GFA AD 513
(ISSUE 2)

TYPE AFFECTED: LS-6, all models, all serial numbers

SUBJECT: Obstruction of emergency canopy jettison.

Rolladen-Schneider Flugzeugbau GmbH LBA-Nr. EB-4 / I-B16	Technical Bulletin No. 6036 / 2	LS6	Page 1 of 2 Edit. 12.Feb.2001
--	---------------------------------	-----	----------------------------------

Deflector with edge protector:

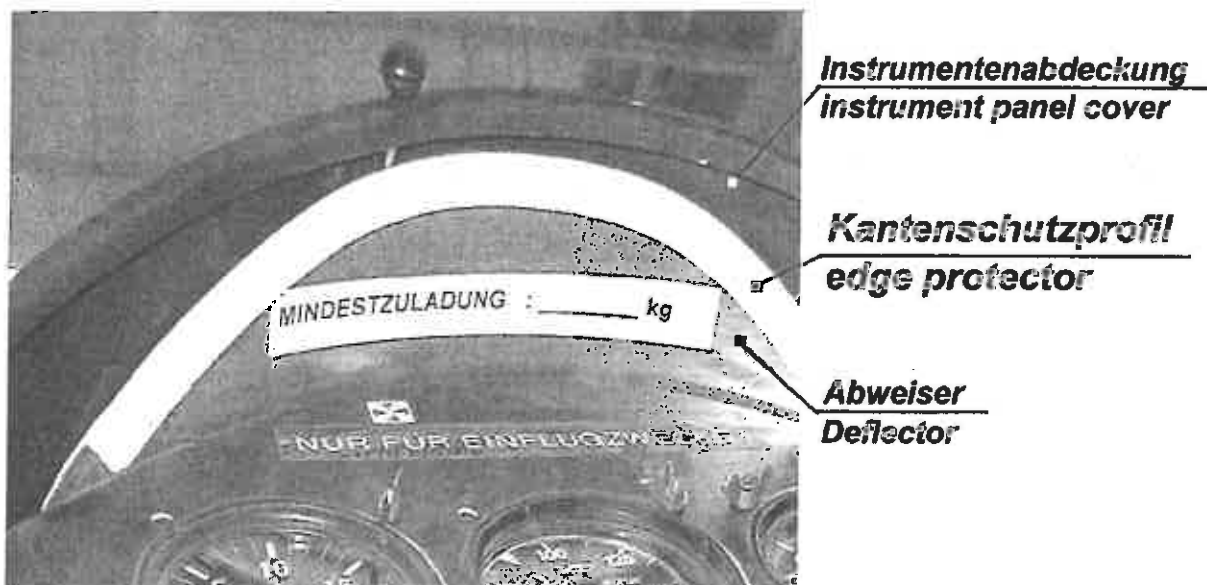
Modification of the Deflector

1. Drill blind rivets. If need be, unscrew upper instruments (Hexagon head 2.5 mm und ratchet with 7mm socket) and place them on top of the second row.
2. Mark new fixing holes 10mm (0.4 in) offset from originals and drill. This enables to use the existing holes at the instrument panel edge.
3. Shorten straight edge of deflector by 10 mm, soften edge and paint black. Maximum depth of deflector after trimming is 100 mm (3.94 in).
4. Rivet deflector back to top of instrument panel, facing towards the pilot (Blind rivets Ø 4mm*6.5, large washers Ø4.3 * 12 * 1mm DIN 9021-St).
5. Push edge protector (as long as instrument panel allows) onto deflector edge.

Should the instrument panel cover be too short to allow the protector to fit underneath, contact manufacturer stating model and serial number.
